YORKSHIRE GARDENS TRUST

Applications for Studley Royal ZC23/02884/LB and ZC23/02883/FUL

Diagrammatic sketch of the effect of the error in calculating the difference between the footprints of the existing and proposed buildings

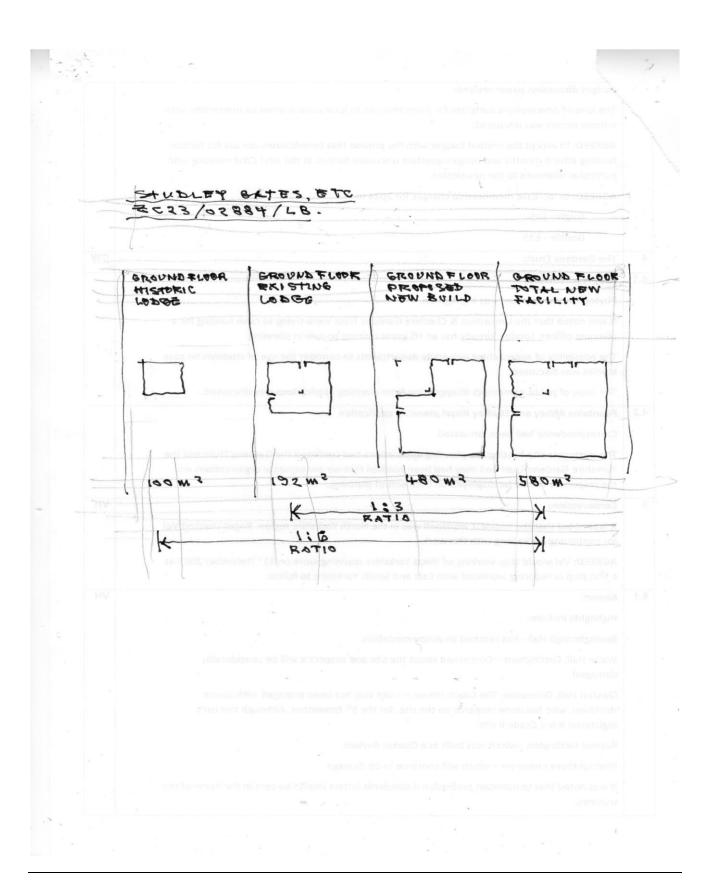
The effect of the error is shown in the table below. As can be seen, the error is material: compared with the footprint of the existing tearoom and its extensions, the proposed building will occupy a footprint 3 times greater; and compared with the footprint of the historic tearoom, the proposed building will occupy a footprint nearly 6 times greater.

should be stated as two times greater than the existing building, giving a total footprint for the new building three times greater than the existing structure.
